**CHANDIGARH
HOUSING BOARD**
A CHANDIGARH ADMINISTRATION UNDERTAKING

No.CHB/EO/DY.EO-I/2022/ 4013

The allottee / occupant
House No. 634-1, Sector 41-A
Chandigarh

Subject : Additional construction / violations in Duplex Flats in Sector 41-A, Chandigarh.

H. No. 634/1, SEC. 41-A

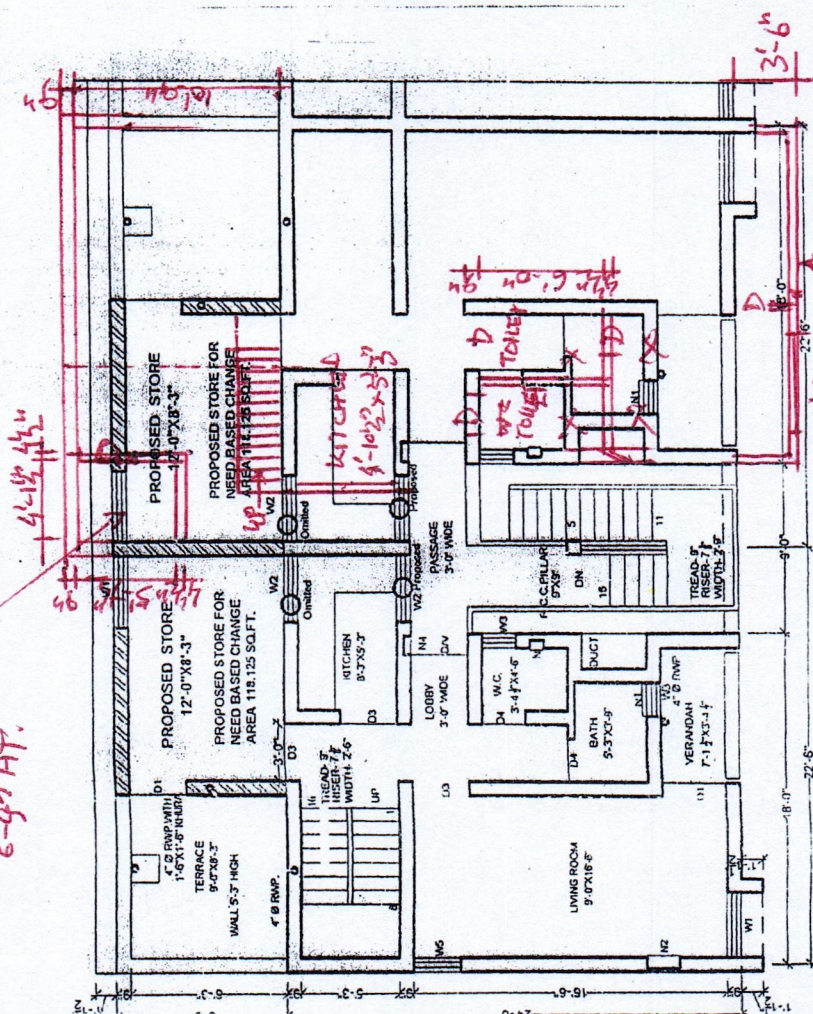
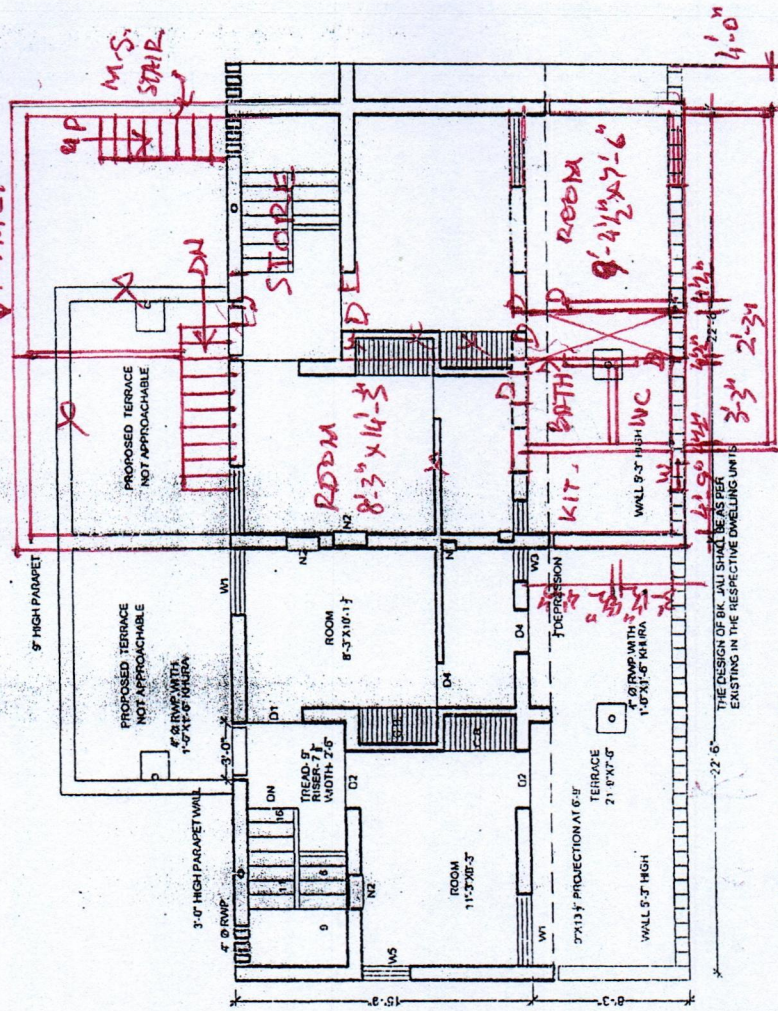
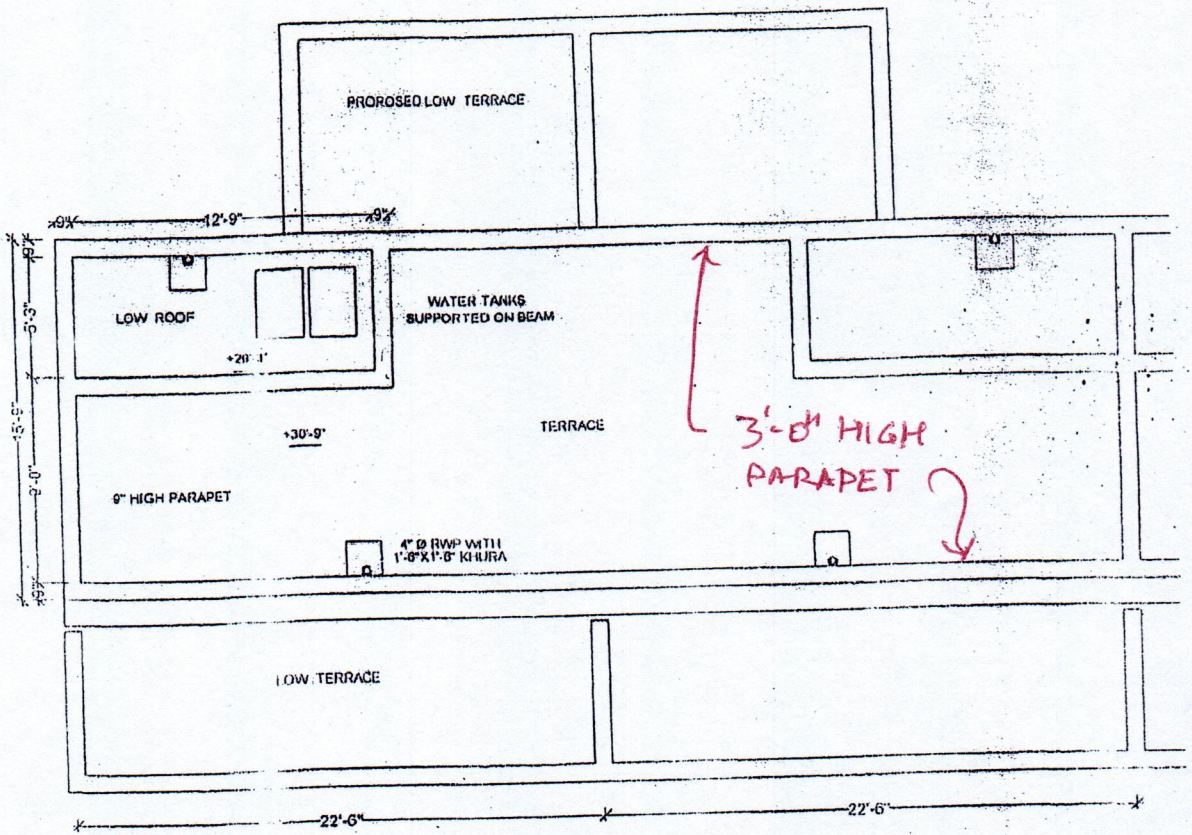
In compliance of the orders of Hon'ble court, survey work of all duplex flats in Sector 41-A, Chandigarh has been done and '**As Built up plans**' of all dwelling units have been prepared. Accordingly, 'As built up plan' of the above said dwelling unit (copy enclosed) depicts that the additional construction / violations made in the said DU is not compoundable / not covered under need based changes policy dated 15.02.2019.

As such, you are advised to remove / set right the violations as per standard drawing of CHB to ensure the structural stability / safety **within 30 days** positively under intimation to this office along with Structure Stability Certificate issued by the empanelled Structural Engineer by Chandigarh Administration, failing which the action will be taken by CHB as per rules / policy and as per the directions of Hon'ble High Court.
